Application Serial No. ....10/821,781  
Filing Date..... April 9, 2004  
Confirmation No.....1454  
Appellants.....Stefan Barkaro, *et al.*  
Group Art Unit.....2614  
Examiner .....Jamal, Alexander  
Attorney Docket No. .... LAN0033US  
Title: .....ECHO CANCELING ARRANGEMENT

**APPEAL BRIEF**

Pursuant to 37 C.F.R. §41.37, Appellants hereby submit a second revised Appeal Brief for Application No. 10/821,781, filed April 9, 2004. This second revised Appeal Brief is being sent pursuant to the Notification of Non-Compliant Appeal Brief that was issued on May 13, 2010.

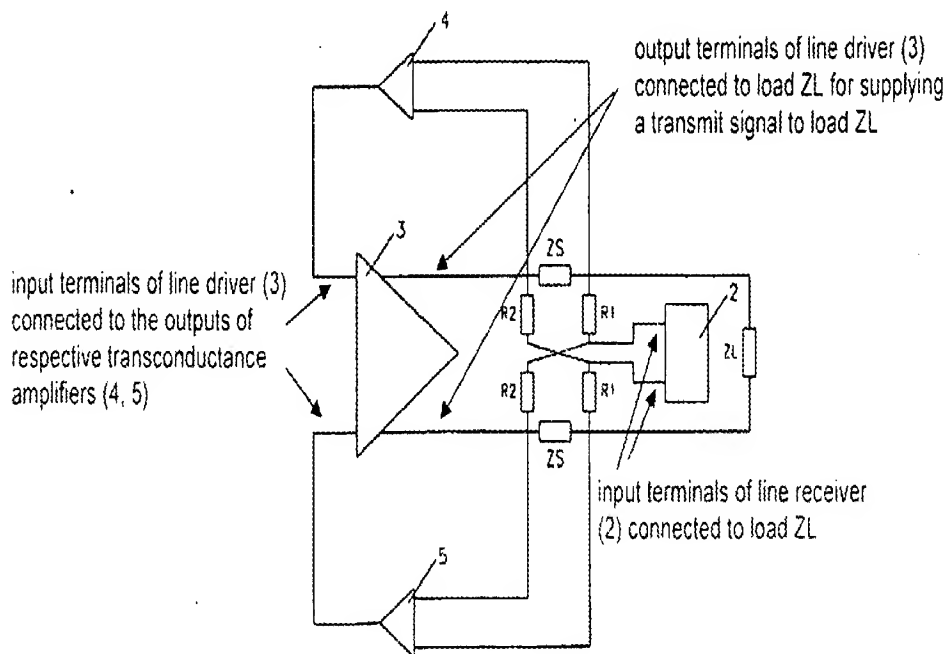
The drawings of the present application are objected to under 37 CFR §1.83(a) as, allegedly, failing to show every feature of the invention specified in the claims. In particular, the objection states that, “the means for coupling the claimed ‘transmit signal’ along with the claimed input terminals receiving the signals from the transductance stages must be shown or the feature(s) canceled from the claim(s).”

With regard to **Claim 1**, Fig. 2 of the present application is shown below, with annotations, to show certain features of the rejected claim. Fig. 2 shows a line driver **3** having output terminals connected to a load **ZL** to supply a transmit signal to the load **ZL** and a line receiver **2** having input terminals connected to the load **ZL** to simultaneously receive a received signal from the load **ZL**. Fig. 2 further shows an arrangement, including resistor bridge **R1**, **R2**, to cancel the transmit signal on the input terminals of the line receiver **2**. The output terminals of the line driver **3** are shown as being connected to the load **ZL** via equal first impedances **ZS** and the input terminals of the line receiver **2** as being connected to the load **ZL** via equal first resistors **R1** and to respective ones of the line driver output terminals via equal second resistors **R2**.

In Fig. 2, the notation “Z” denotes that the first impedances “**ZS**” may be complex, as claimed. At [0028] of the published application, first impedances **ZS** are described as being complex, and it is further described that first impedances **ZS** may be of an impedance value that is much smaller than an impedance value of the load **ZL**, as in Claim 1.

The Appellants further submit, respectfully, that the connection by which signals are transmitted from the out terminals of the respective transductance amplifiers **4, 5** to the input terminal of the line driver **3** is clearly depicted in Fig. 2 of the present application. That is, the drawing fully illustrates the coupling of the respective transductance amplifiers **4, 5** with the respective impedances **ZS** and the outputs thereof to the input of line driver **3**.

Further, at [0031] of the application, the drive/termination impedance of the line driver **3** is described as equaling  $k \times \mathbf{ZS}$ , whereby “k” is a gain-related function and “**ZS**” is the value of the first impedance. The drive/termination impedance of the line driver, therefore, is a function of both gain and the value of the impedances **ZS**. Thus, the drive/termination impedance of the line driver **3** can be matched to the load when  $k \times \mathbf{ZS} = \mathbf{ZL}$ , as currently recited.

The rejection states, even further, that one of ordinary skill would not be able to determine what the relative size, *i.e.*, “much smaller,” would be as recited in Claim 1. In respectfully disagreeing, the Appellants submit that one of ordinary skill would know, by the aforementioned formula from [0031] of the specification, that “much smaller” could easily be approximated by the load impedance **ZL** divided by the gain factor k, *i.e.*,  $\mathbf{ZS} = \mathbf{ZL} \div k$ . That is, “much smaller” is easily determined to be approximately 1/k of the load impedance.

Fig. 2 also shows that the transconductance amplifiers **4, 5** are provided to sense the voltage across the first impedances **ZS** and to supply corresponding currents to respective ones of the line driver input terminals, as claimed. Thus, each feature of Claim 1 is sufficiently illustrated and described in the application to enable one skilled in the art to practice that which is claimed, per the requirements of 35 U.S.C. §112, first paragraph.

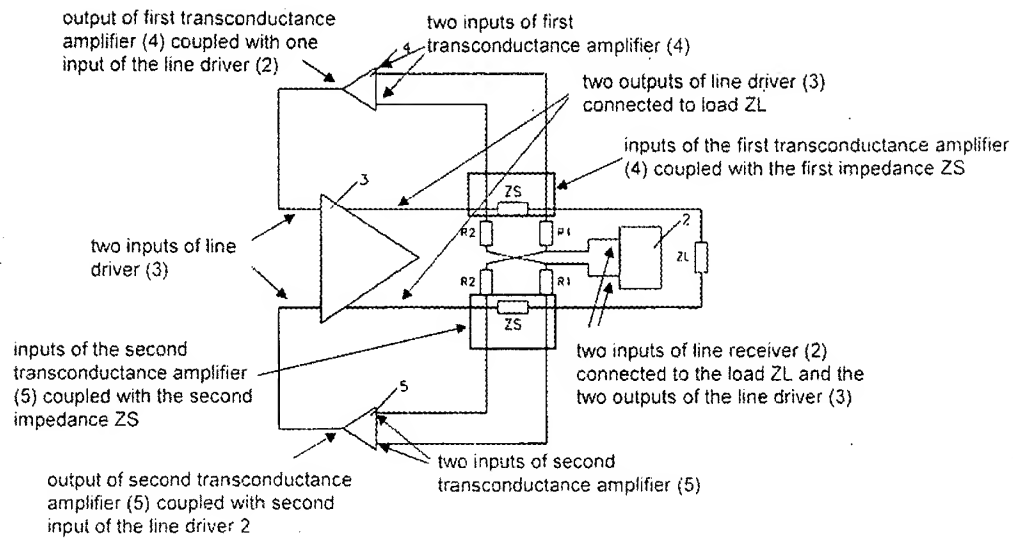
With regard to all of the appealed claims, particularly independent Claims 1, 3, and 7, the rejection states that the claims recite “first impedances which are ‘complex impedances to match the load impedance, and are of an impedance value that is much smaller than the impedance value of the load’.” The Appellants respectfully submit that the rejection includes an inaccurate characterization of the claimed subject matter. Instead, what is actually recited is:

Fig. 2 of the present application is shown again below, with annotations, to show certain features of the rejected independent **Claim 3**. Fig. 2 shows a line driver **3** that has two inputs and two outputs, as well as a load **ZL** coupled with the outputs of the line driver **3** via first and second impedances **ZS**, as recited in Claim 3. Further shown is a line receiver **2** that has two inputs coupled through a network, *i.e.*, resistor bridge **R1**, **R2**, with the load **ZL** and the outputs of the line driver **2**. Further still, Fig. 2 shows first and second transconductance amplifiers **4**, **5**, that have two inputs and an output, as recited in Claim 3. The inputs of the first transconductance amplifier **4** are coupled with the first impedance **ZS** and its output is coupled with one input of the line driver **2**, and the inputs of the second transconductance amplifier **5** are coupled with the second impedance **ZS** and its output is coupled with the other input of the line driver **2**, as claimed. The first and second impedances are described as being complex impedances of a value that is much smaller than an impedance value of the load **ZL** so that a drive/termination impedance of the line driver **2** matches the load impedance **ZL**, as claimed, at [0021], [0028], and [0031].
